Service Bulletin

Bulletin No.: 15-08-51-001A

Subject: Availability of Insulator Service Part for Prevention of Liftgate Rust/Corrosion at Center Applique

Models: 2010-2015 Chevrolet Equinox
2010-2015 GMC Terrain

4252404

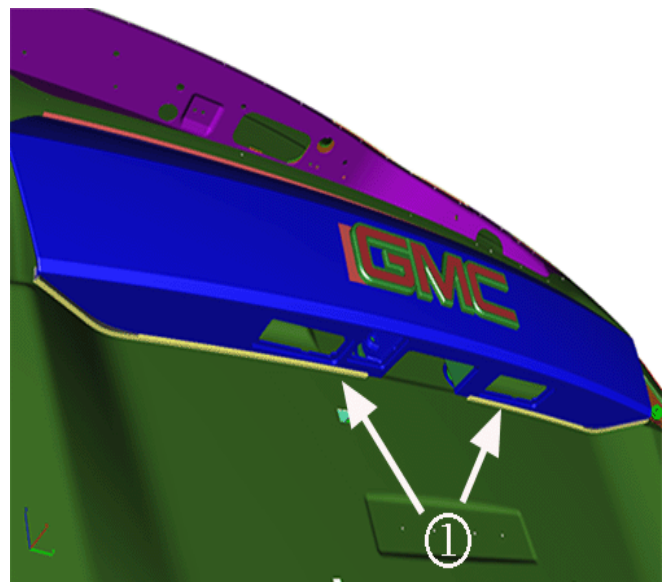
On some vehicles, due to the applique contacting and rubbing on the liftgate painted surface, rust spots (shown circled above) may be evident at the lower corners of the center chrome applique on the rear liftgate.

When repairing this rust spot condition, it will be necessary to remove the original applique, and repair any rust spot condition following common industry standards. Then, depending on model being repaired, follow the appropriate service part replacement advised below:

4252408

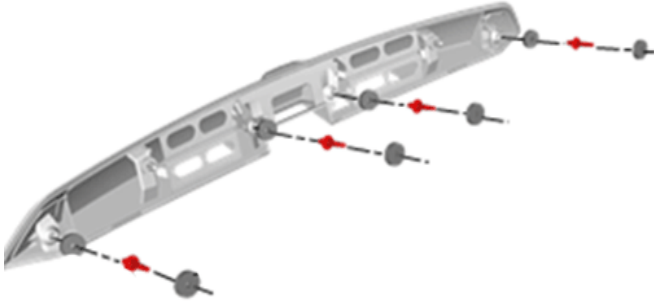
- **For Terrain models**, a two piece insulator is available as a service part, separate from the applique assembly. After repairing the rust condition, the new insulator parts (1) should be installed between the original applique and the liftgate. Refer to *Rear Closure Center Applique Insulator Replacement (GMC)* in SI.
